**Notice of Allowability**

10/821,831

GABL ET AL.

Authorization for this examiner's amendment was given in a telephone interview with Mr. Clifford Kelly on 5-26-06.

Fig 1

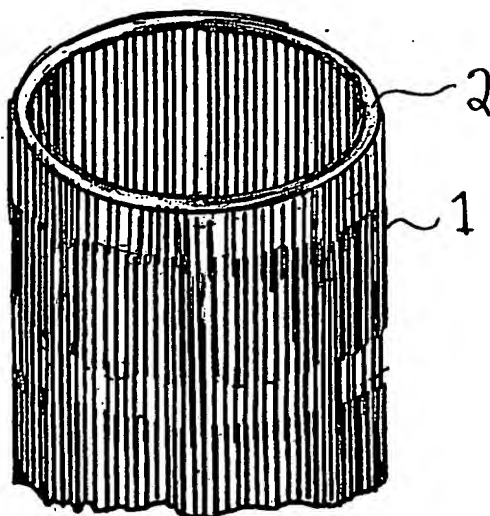
The following changes to the drawings have been approved by the examiner and agreed upon by applicant: A new FIG. 3 must be added showing a cylindrical screen having support elements and rods arranged as shown in FIG. 1 with exposed portions of the rods facing an interior of the cylindrical screen. It is noted that the previous new FIG. 3 submitted on 3-13-06 was denied entry by the examiner as incorporating new matter since the support members and rods were improperly drawn and because the drawing was labeled "Replacement Sheet" which was improper. Applicant must label the new FIG. 3 as "New Figure" in the upper margin of the sheet. In order to avoid abandonment of the application, applicant must make these above agreed upon drawing changes.

OKay to enter. ms
